**ASHLAND PLANNING DEPARTMENT
PRE-APPLICATION CONFERENCE
COMMENT SHEET**
November 12, 2025

SITE: 1819 Dragonfly Lane
APPLICANT: Jason Davis
REQUEST: Physical & Environmental
Constraints Review Permit for rear yard and
retaining wall

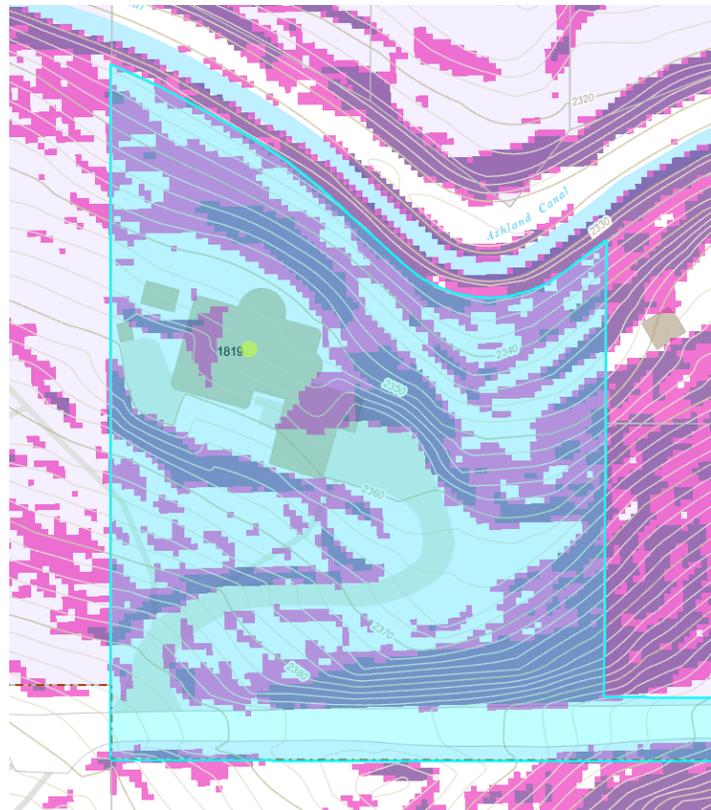
The property located at 1819 Dragonfly Lane is a fairly steep sloped lot with a portion of the lot labeled as ‘severely constrained’ (slopes greater than 35%). On the image below (generated by City GIS) the dark magenta are slopes greater than 35%, and light magenta showing slopes greater than 25%. The land use ordinance requires all new construction to happen on slopes less than 35%, however AMC 18.3.10.090.A.1.a allows for “Existing parcels without adequate buildable area less than or equal to 35 percent shall be considered buildable for one unit.” Because of steepness of the property and the presence of slopes greater than 35% a Physical and Environmental Constraints Review Permit is required.
